<b>ITEM: 6.11</b>	<b>COMMITTEE OF ADJUSTMENT REPORT SUMMARY MINOR VARIANCE APPLICATION FILE NUMBER A195/23 77 WOODSTREAM BLVD, WOODBRIDGE</b>
-------------------	---

**COMMITTEE OF ADJUSTMENT REPORT  
MINOR VARIANCE APPLICATION  
A195/23  
77 WOODSTREAM BLVD, WOODBRIDGE**

<b>ITEM NUMBER: 6.11</b>	<b>CITY WARD #: 2</b>
<b>APPLICANT:</b>	77 Woodstream Inc.
<b>AGENT:</b>	Humphries Planning Group Inc.
<b>PROPERTY:</b>	77 Woodstream Blvd, Woodbridge
<b>ZONING DESIGNATION:</b>	See Below
<b>VAUGHAN OFFICIAL PLAN (2010) DESIGNATION:</b>	Vaughan Official Plan 2010 ('VOP 2010'): "High-Rise Mixed-Use"
<b>RELATED DEVELOPMENT APPLICATIONS:</b>	DA.15.072
<b>PURPOSE OF APPLICATION:</b>	Relief from the Zoning By-law is being requested to permit the indoor amenity area located within the ground floor and 2nd floor podium (as shown on the plans submitted) to be 931 square metres.  Relief is required to facilitate related Site Plan Amendment Application DA.15.072, which proposes a residential complex including two (2) high-rise condominium towers and three (3) townhouse blocks.

**2nd Floor Plan**

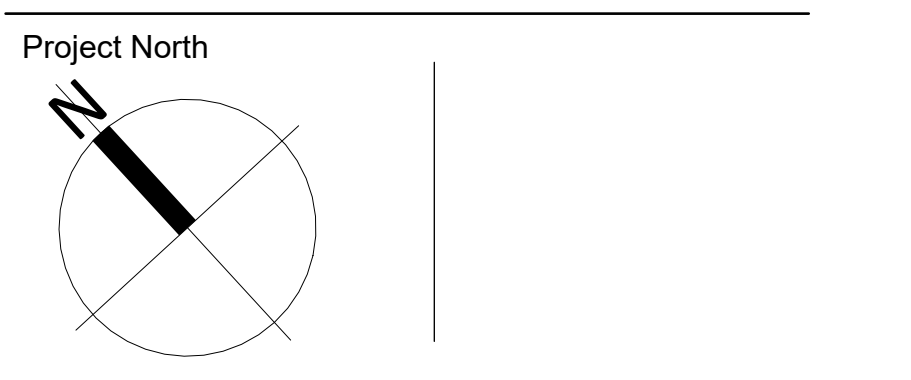
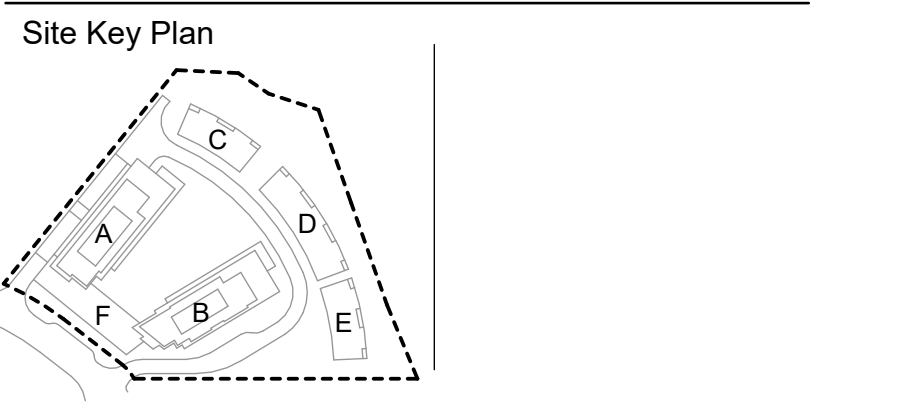
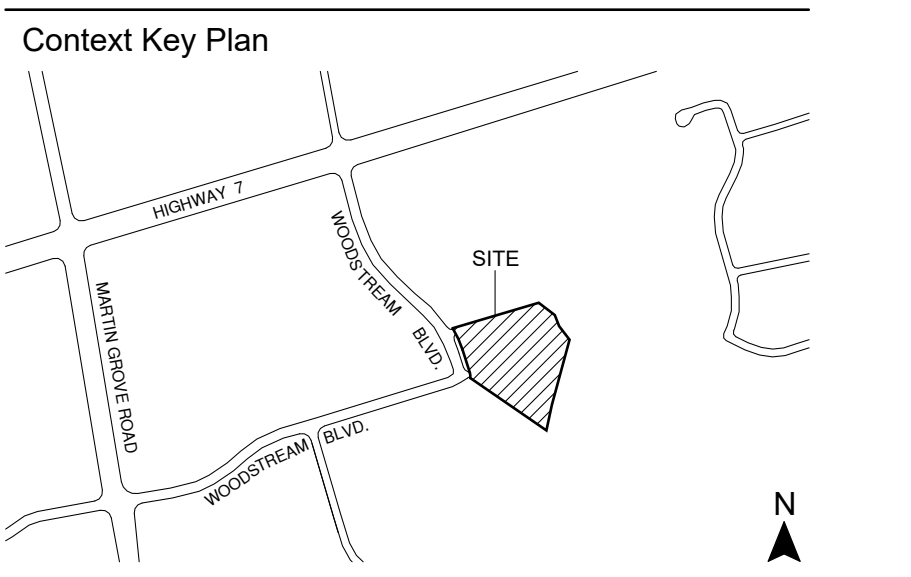
The Development Planning Department has no objection to Variances 1 and 2 for the relocation of the indoor amenity area of 931.0 m<sup>2</sup> from the third floor to the second floor. The variances to the site-specific provisions will not result in any additional gross floor area and the proposed relocation does not reduce or supersede the overall amenity area required by By-law 187-2020, Section 14.1129.4.2.f.i. The relocation of the amenity area has been reviewed through the Site Development Application process and is considered appropriate for the greater development and is not anticipated to have adverse impacts to the overall functionality of the total development.
